FALCON RANCHETTES FILING NO. 1A

A REPLAT OF LOTS 1 & 2, FALCON RANCHETTES LOCATED IN THE SOUTHEAST QUARTER OF SECTION 1, TOWNSHIP 13 SOUTH, RANGE 65 WEST OF THE 6TH PRINCIPAL MERIDIAN, COUNTY OF EL PASO, STATE OF COLORADO

PCD FILE NO.: VR239

SHEET 1 OF 3

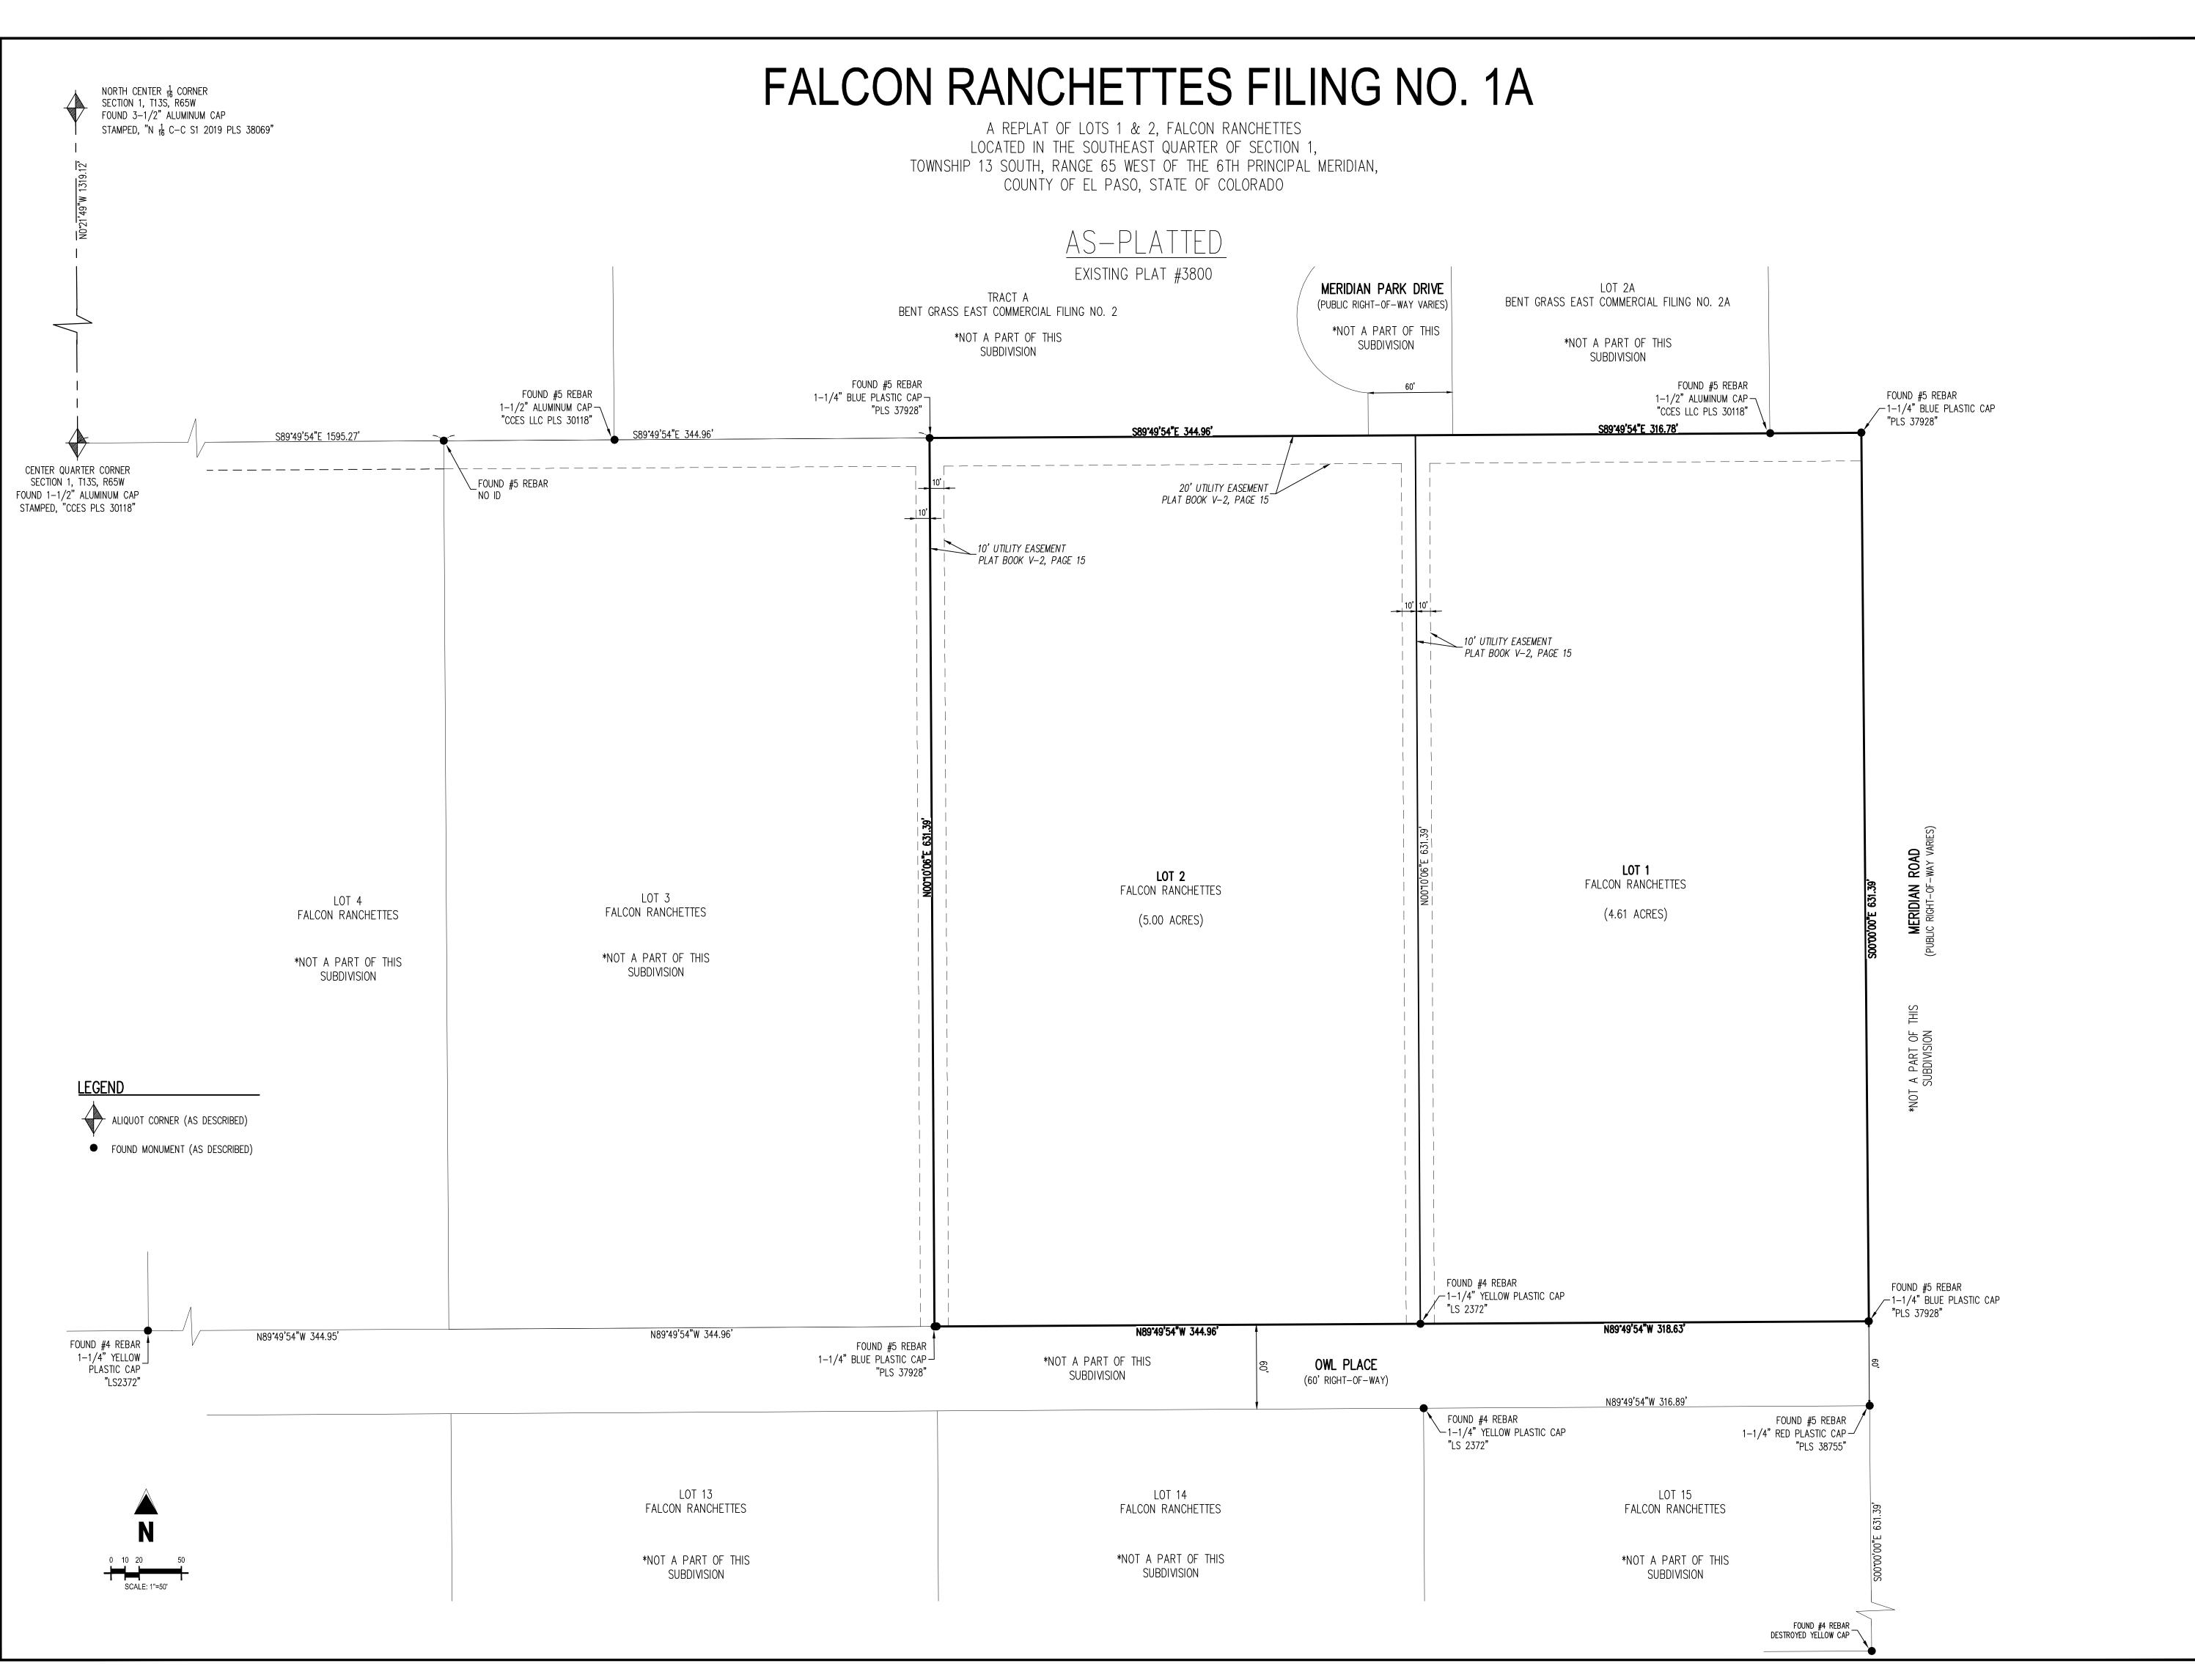
The Soil and Geology Conditions note on the Final Plat should be updated to reference UES's 2/22/2024 report.

Add the following note:

see WASTEWATER note section below SOIL AND GEOLOGY CONDITI - note revised to be site specific

ease remove this

ote as the southerly

evelopment has

proposed a right in

ease specify that

drainage easement

on the east side of

he property along

Meridian Road.

nis is the 30'

Soil and Geology Conditions note updated to reference the 06/20/2024 UES Report.

note 17 deleted

30' easement along Meridian road

BRITTANY A. TEXER note 20 revised to specify
